WHATCOM COUNTY LAND DISTURBANCE AND CLEARING

Geotechnical Investigation Project Description

**Subject: Gateway Pacific Terminal – Addendum to the Proposed Temporary Erosion
and Sedimentation Plan**

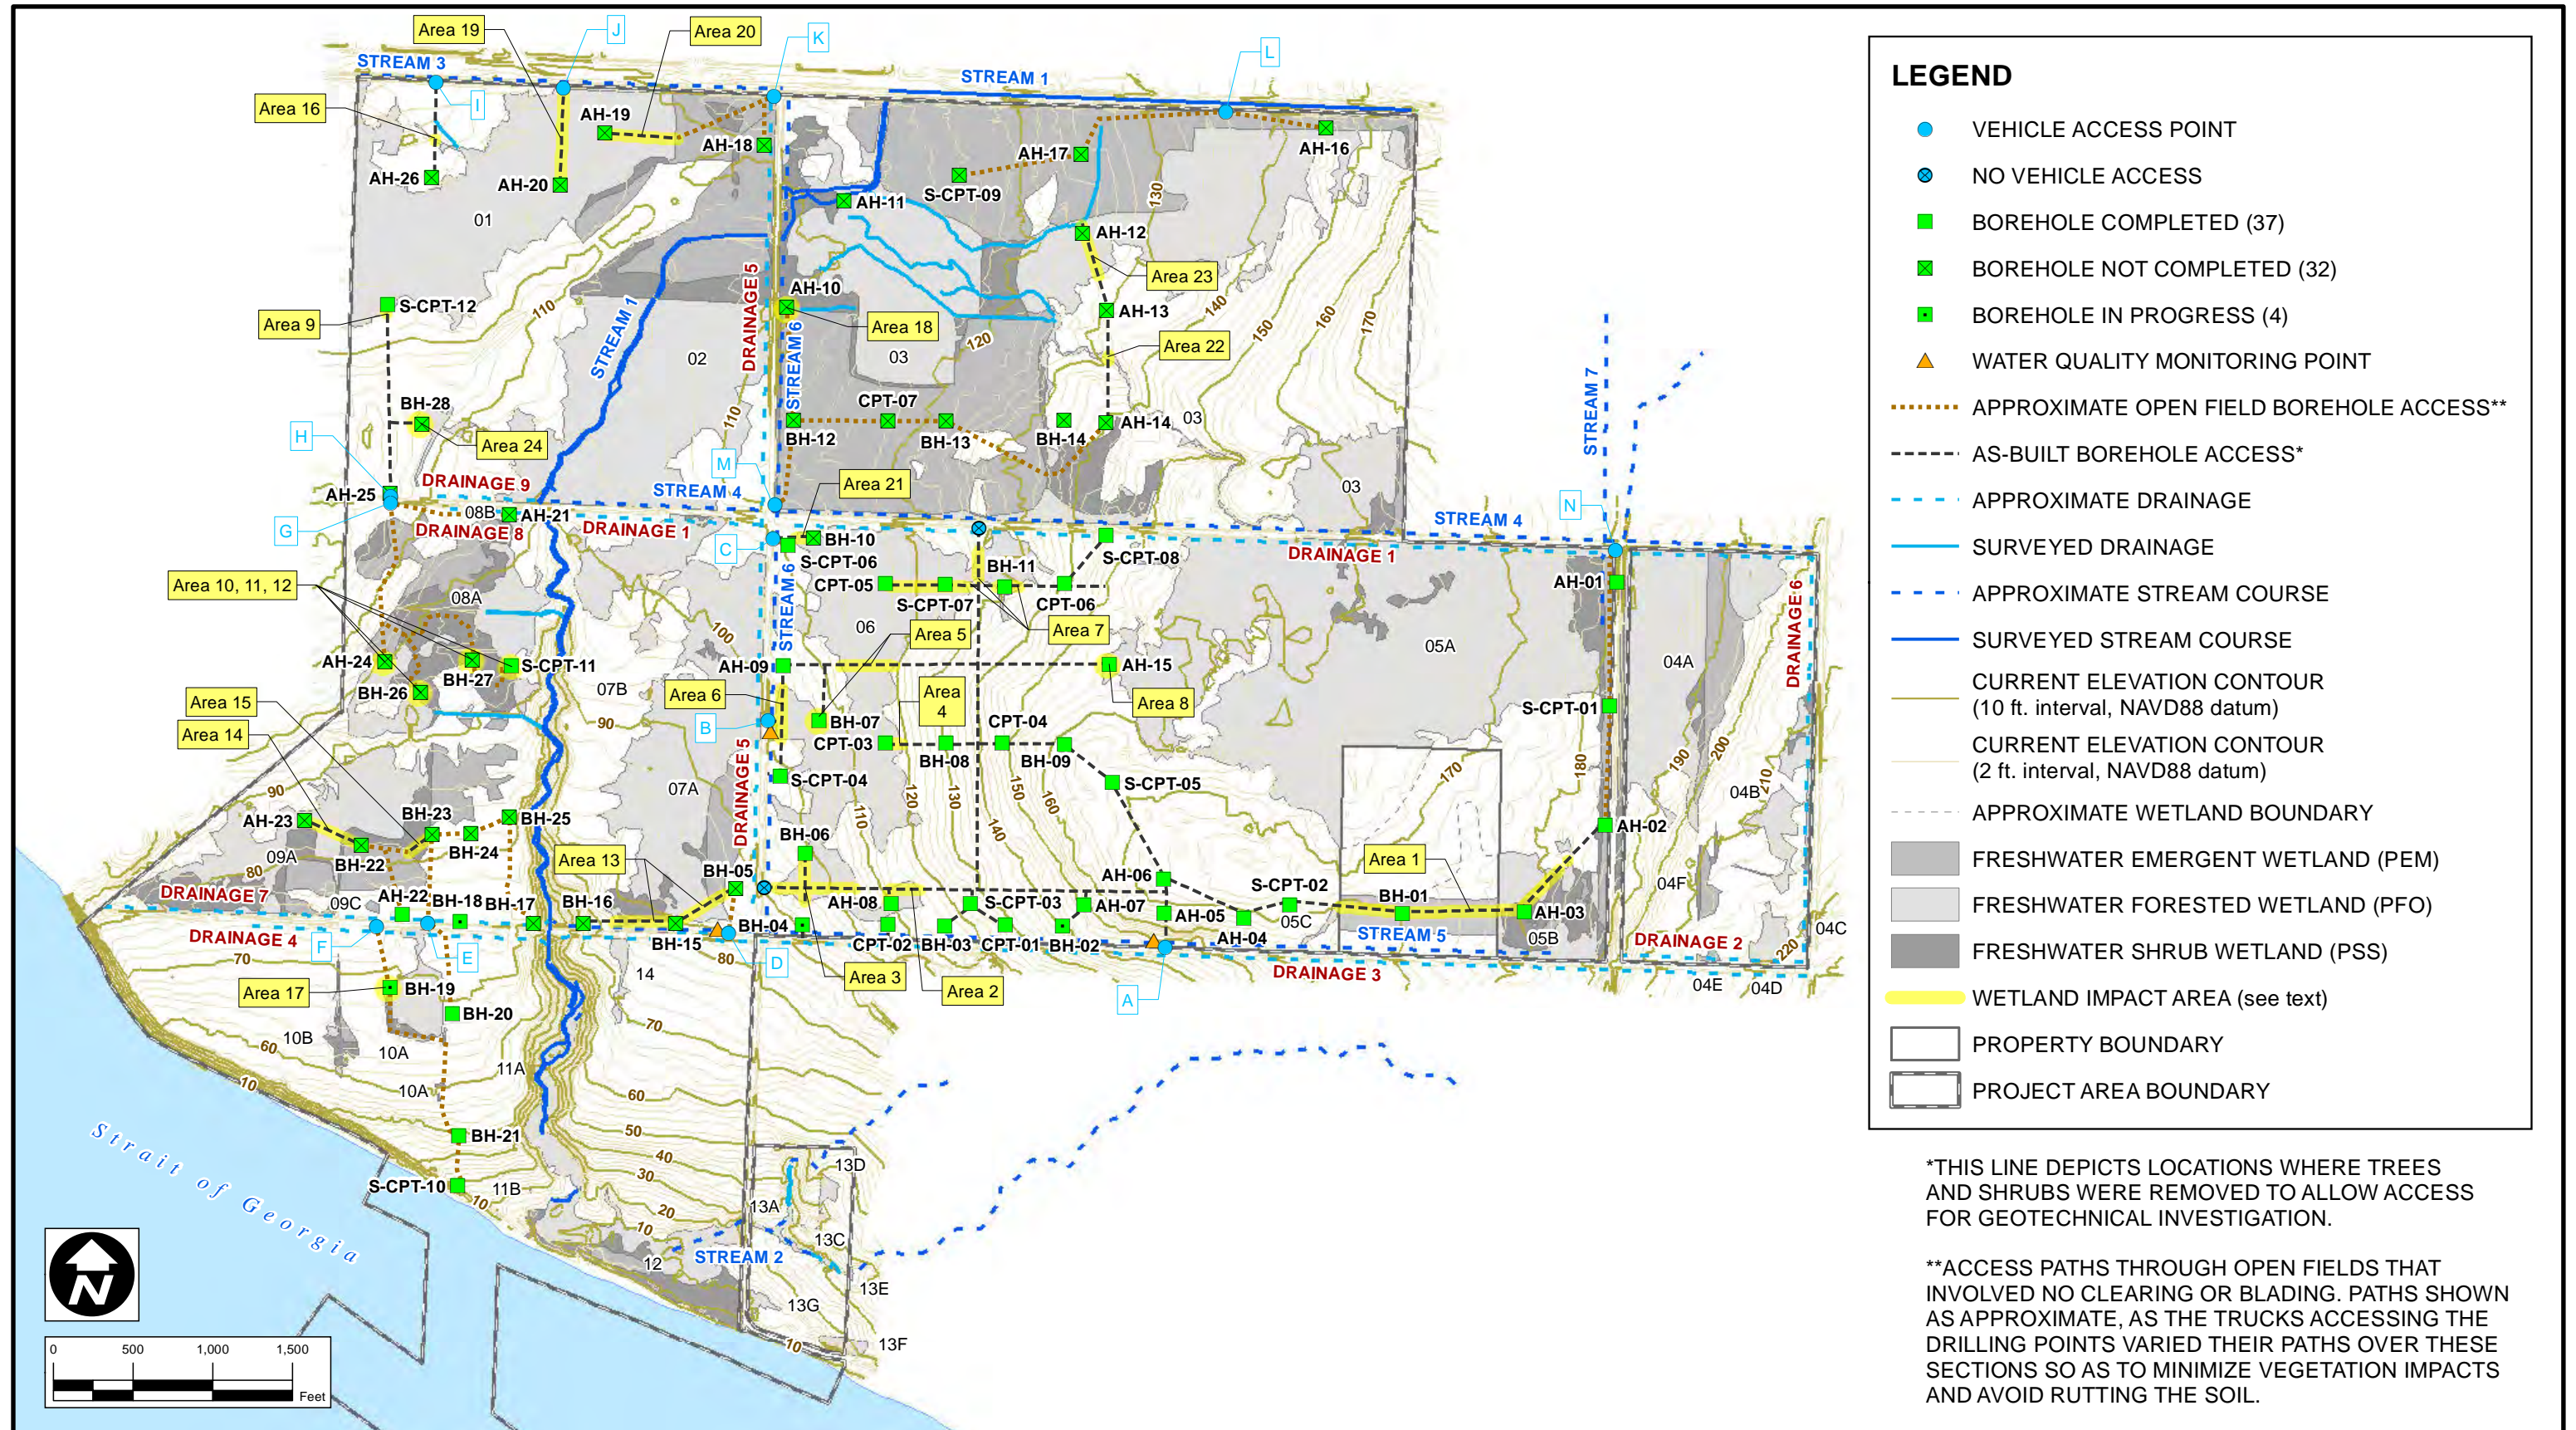
On Tuesday of this week, you met with Cliff Strong, our planner on the Gateway Pacific Terminal project. In the meeting, you raised several questions regarding our proposed Temporary Erosion and Sedimentation Plan (TESC) plan. Please consider the below responses an addendum to that plan. Addenda are shown in underline/underline.

The site is relatively flat ground with a slight slope to the west. An attached figure shows the approximately location of access paths to be stabilized (Figure 1). As per your request, the map now shows access routes where machinery crossed open fields even though no clearing or blading was performed (and, thus, no erosion control is needed).
